# Technical Service Bulletin

SUBJECT:			No: <b>TSB-11-13-008REVII</b>
<b>ECM REPROGRAMMING FOR DTC P0016 or P0017: CRANKSHAFT/CAMSHAFT POSITION</b>			DATE: <b>November, 2011</b>
			MODEL: <b>See below</b>
CIRCULATE TO:	<input type="checkbox"/> GENERAL MANAGER	<input type="checkbox"/> PARTS MANAGER	<input checked="" type="checkbox"/> TECHNICIAN
<input checked="" type="checkbox"/> SERVICE ADVISOR	<input checked="" type="checkbox"/> SERVICE MANAGER	<input checked="" type="checkbox"/> WARRANTY PROCESSOR	<input type="checkbox"/> SALES MANAGER

***This bulletin supercedes TSB-11-13-008REV, issued November, 2011, to include non-turbo vehicles as requiring MIVEC oil valve and timing chain elongation checks. Changes are italicized and indicated by ◀.***

**ECM REPROGRAMMING CHART**

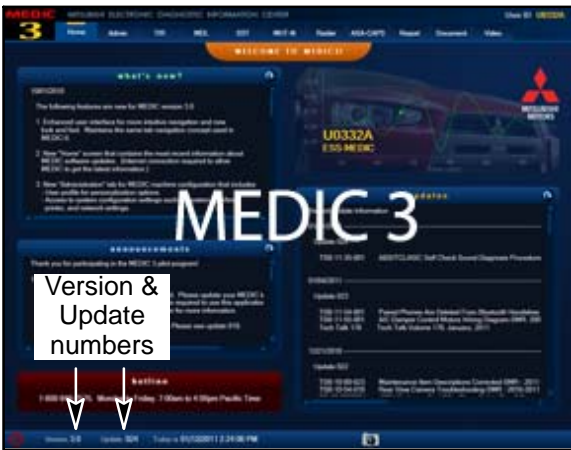
MODEL MODEL YEAR – 2011 (TC* = Turbocharged)	CURRENT PART NO.	DATA NO.	DISPLAY ON MUT-III AFTER REPROGRAMMING	
			New Part No.	New S/W Part No.
<i>11 NAS Lancer Evolution 4B11 TC* 5M/T</i>	<i>1860B474</i>	<i>1862B357</i>	<i>1860B474</i>	<i>1860B47403</i>
<i>11 NAS Lancer Evolution 4B11 TC* TC/SST</i>	<i>1860B475</i>	<i>1862B445</i>	<i>1860B475</i>	<i>1860B47503</i>
<i>11 Lancer/Lancer Sportback CALF 4B11 D4 VVT MT</i>	<i>1860B362</i>	<i>1862B419</i>	<i>1860B362</i>	<i>1860B36204</i>
<i>11 Lancer/Lancer Sportback CALF 4B11 D4 VVT CVT</i>	<i>1860B363</i>	<i>1862B420</i>	<i>1860B363</i>	<i>1860B36304</i>
<i>11 Lancer/Lancer Sportback FED 4B11 D4 VVT MT</i>	<i>1860B364</i>	<i>1862B434</i>	<i>1860B364</i>	<i>1860B36403</i>
<i>11 Lancer/Lancer Sportback FED 4B11 D4 VVT CVT</i>	<i>1860B365</i>	<i>1862B435</i>	<i>1860B365</i>	<i>1860B36504</i>
<i>11 Lancer/Lancer Sportback 4B11 D4 VVT TC* TC-SST</i>	<i>1860B485</i>	<i>1862B446</i>	<i>1860B485</i>	<i>1860B48503</i>

<i>11 Lancer/Lancer Sportback CALF 4B12 D4 VVT MT</i>	<i>1860B456</i>	<i>1862B436</i>	<i>1860B456</i>	<i>1860B45602</i>
<i>11 Lancer/Lancer Sportback FED 4B12 D4 VVT MT</i>	<i>1860B458</i>	<i>1862B437</i>	<i>1860B458</i>	<i>1860B45802</i>
<i>11 Lancer/Lancer Sportback CALIF 4B12 D4 VVT CVT</i>	<i>1860B457</i>	<i>1862B438</i>	<i>1860B457</i>	<i>1860B45702</i>
<i>11 Lancer/Lancer Sportback FED 4B12 D4 VVT CVT</i>	<i>1860B459</i>	<i>1862B439</i>	<i>1860B459</i>	<i>1860B45902</i>
<i>11 Outlander Sport (RVR) CALF 4B11 D4 CVT</i>	<i>1860B637</i>	<i>1862B418</i>	<i>1860B637</i>	<i>1860B63703</i>
<i>11 Outlander Sport (RVR) FED 4B11 D4 MT</i>	<i>1860B665</i>	<i>1862B431</i>	<i>1860B665</i>	<i>1860B66502</i>
<i>11 Outlander Sport (RVR) FED 4B11 D4 CVT</i>	<i>1860B638</i>	<i>1862B432</i>	<i>1860B638</i>	<i>1860B63803</i>
<i>11 Outlander CALIF (4WD) 4B12 D4 CVT</i>	<i>1860B461</i>	<i>1862B433</i>	<i>1860B461</i>	<i>1860B46102</i>
